Appl. No. 10/762,671
Amendment dated April 4, 2005
Reply to Office Action of December 2, 2004

Amendments to the Drawing:

FIG.11C-a

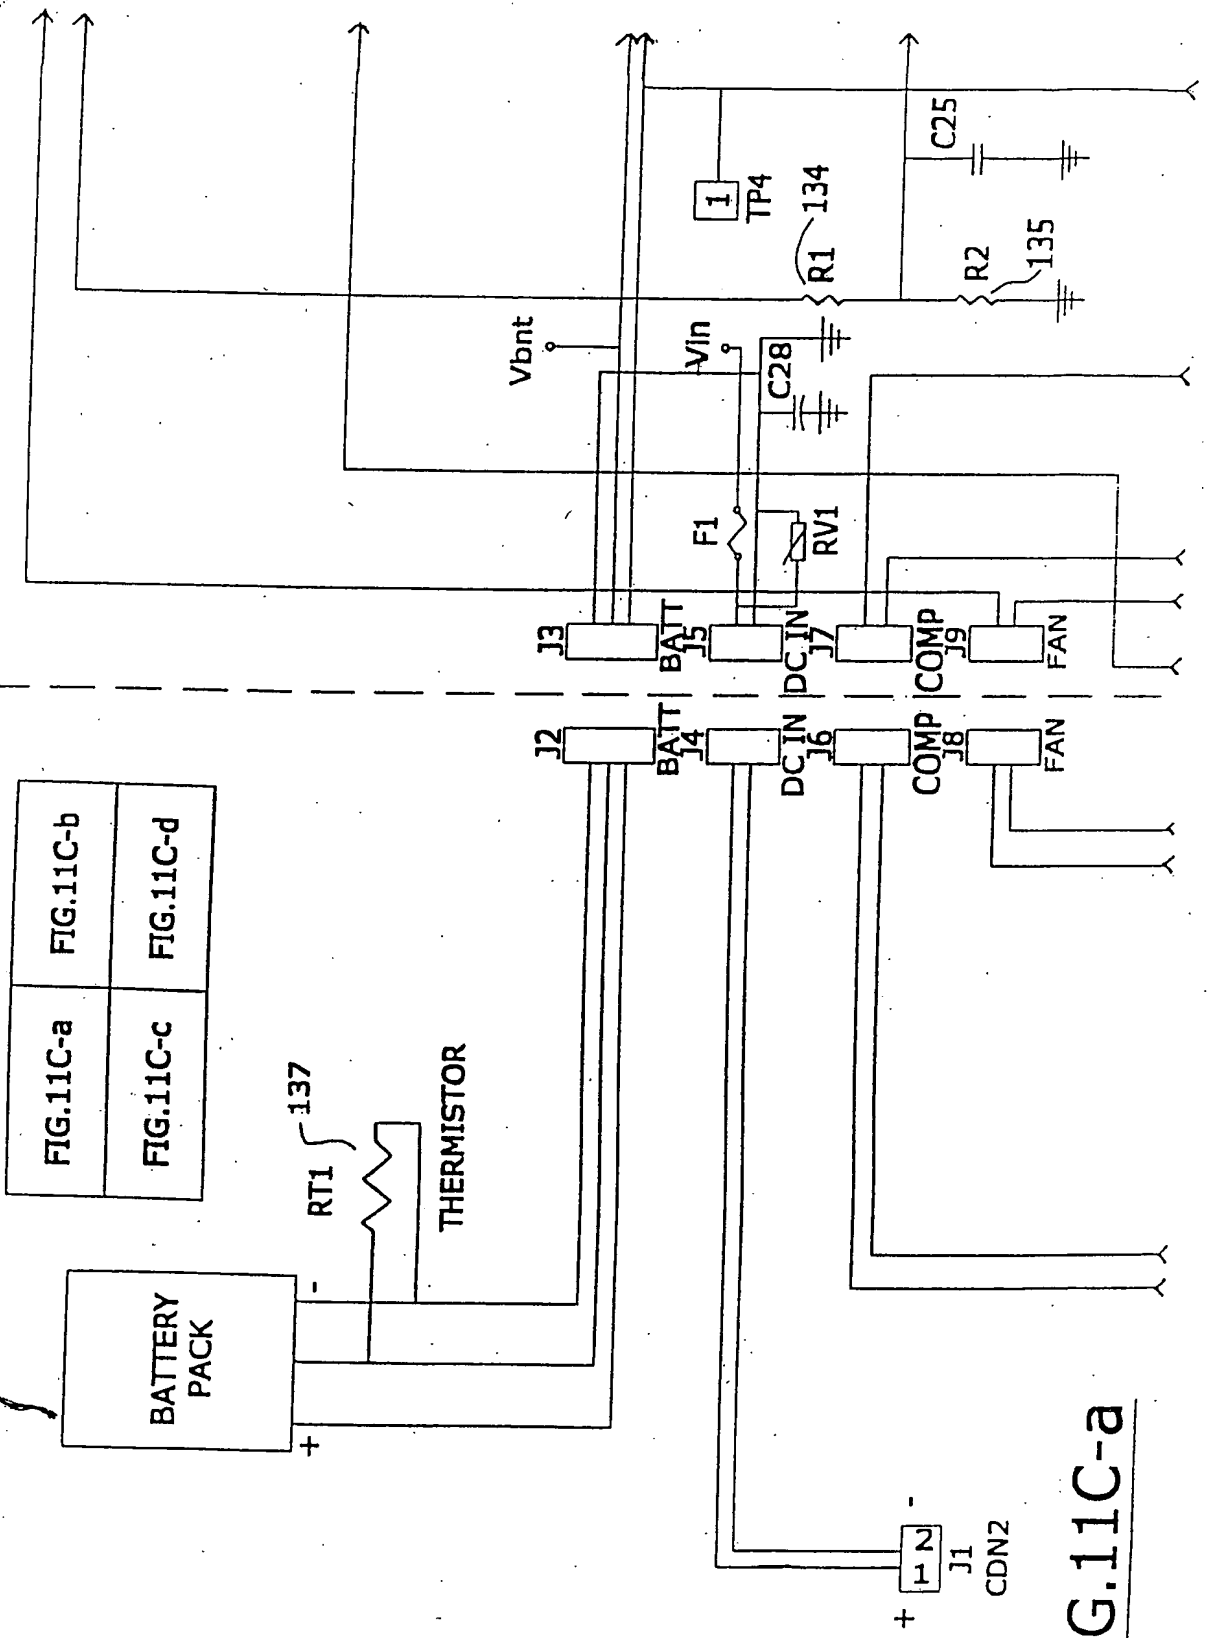
Please replace Drawing Sheets 14, 18 and 19, containing FIGS. 11C-a, 11D-a and 11D-b, respectively, with the attached amended and corresponding Drawing Sheets, in which missing reference numerals as noted by the Examiner are added and shown in red on the drawing copies that follow.

Reference number added
